UNITED STATES PATENT AND TRADEMARK OFFICE

APPLICATION NO.	FILING DATE	FIRST NAMED INVENTOR	ATTORNEY DOCKET NO.	CONFIRMATION NO.
10/659,731	09/10/2003	John M. Vincak	10532	3889

Office Action Summary

This is the second office action for application number 10/659,731, Work Stand, filed on September 10, 2003.

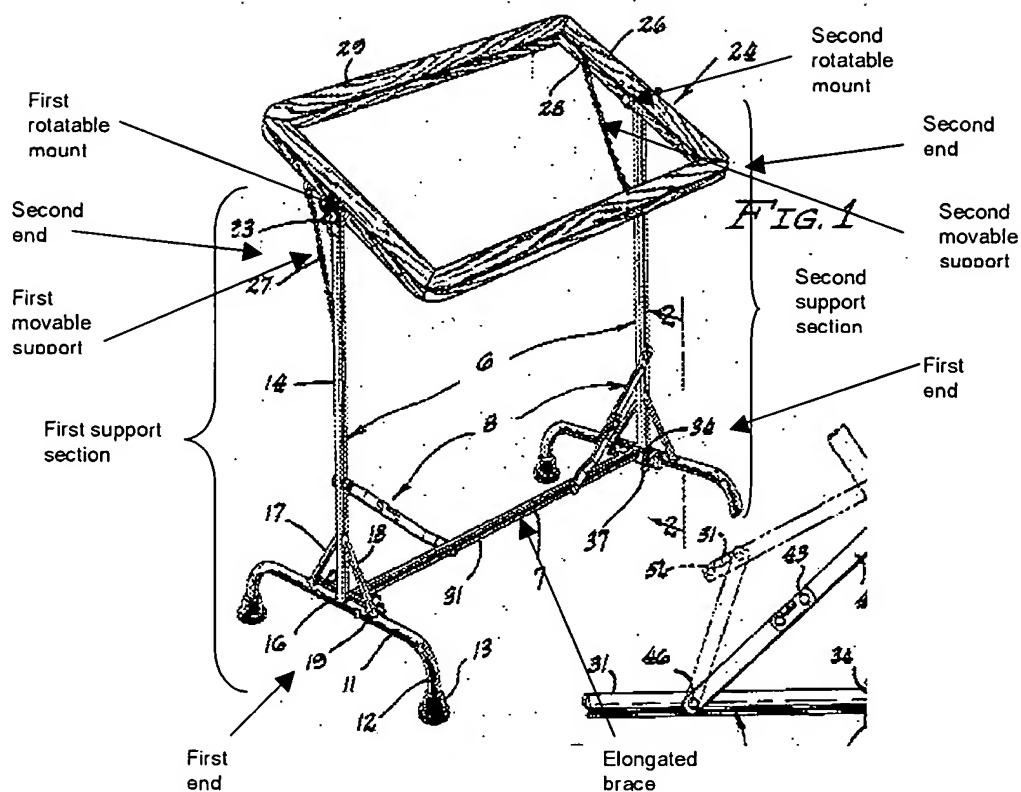
Claims 1-4, 6 and 7 are rejected under 35 U.S.C. 102(b) as being anticipated by U.S. Patent number 2,675,981 to Ferris.

Ferris '981 discloses a stand (above) comprising first and second support sections (above) each having first and second ends, a first rotatable mount (above) disposed upon the first support section proximate to the second end thereof ("proximate" is defined in Merriam Webster's Collegiate Dictionary - 10th Edition as being "close," so clearly, the first rotatable mount is disposed "close" to second end of the first support section; further, all subsequent uses of the term "proximate" in this office action will use the same meaning, and all features being compared as "proximate" are clearly "close" to one another), a second rotatable mount (above) disposed upon the second support section proximate to the second end thereof, an elongated brace (above) having a first end (left end of elongated brace above) attached to/disposed on the first support section proximate to the first end thereof and a second end (right side of elongated brace above) attached to/disposed on the second support section proximate to the first end

thereof, a first movable support (above) disposed upon the first support section proximate to the first rotatable mount and beneath the first rotatable support, a second movable support (above) disposed upon the second support section proximate to the second rotatable mount and beneath the second rotatable mount.

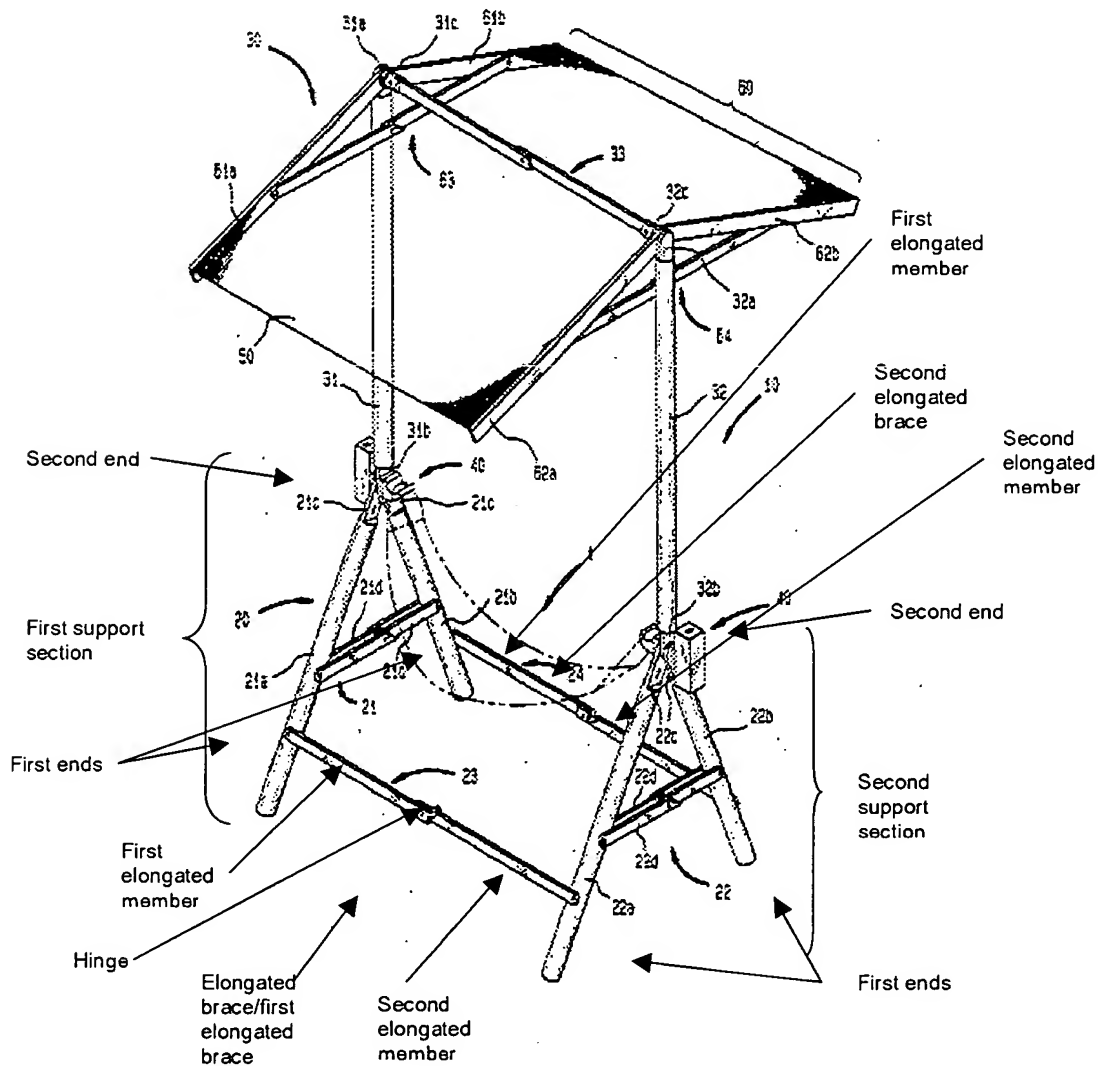
Claims 1-4 and 10-12 are rejected under 35 U.S.C. 102(b) as being anticipated by U.S. Patent number 5,046,203 to de Cuadros.

Regarding claims 1-4, 10 and 11, de Cuadros '203 discloses a stand (above) comprising first and second support sections (above) each having first and second ends, a first rotatable mount (41, it can rotate about the threads) disposed upon the first support section proximate to the second end thereof, a second rotatable mount (41, it can be rotated about the threads) disposed upon the second support section proximate to the second end thereof, a first movable support (31,31b, see column 3, lines 2-3, "pivotally") disposed upon the first support section proximate to the first rotatable mount, an elongated brace (above) having a first end (left end of elongated brace above) attached to/disposed on the first support section proximate to the first end thereof and a second end (right side of elongated brace above) attached to/disposed on the second support section proximate to the first end thereof, wherein the elongated brace further comprises a first elongated member (above) having first and second ends (left and right sides respectively, above), and a second elongated member (above) having first and second ends (right and left sides respectively, above), whereby the first end of the first elongated member is pivotally attached to the first support section proximate to the first end of the first support section, the first end of the second elongated member is pivotally attached to the second support section proximate to the first end of the second support section, and the second end of the first elongated member is pivotally attached to the second end of the second elongated member, wherein a hinge (above, 33f, see column 3, lines 35-52).

Further, regarding claim 12, de Cuadros '203 teaches the first support section to have first and second legs (21a,21b) each having first and second ends (above), wherein the second ends of the first and second legs are substantially together and the first ends of the first and second legs are substantially apart, and the second support section to have first and second legs (22a,22b) each having first and second ends (above), wherein the second ends of the first and
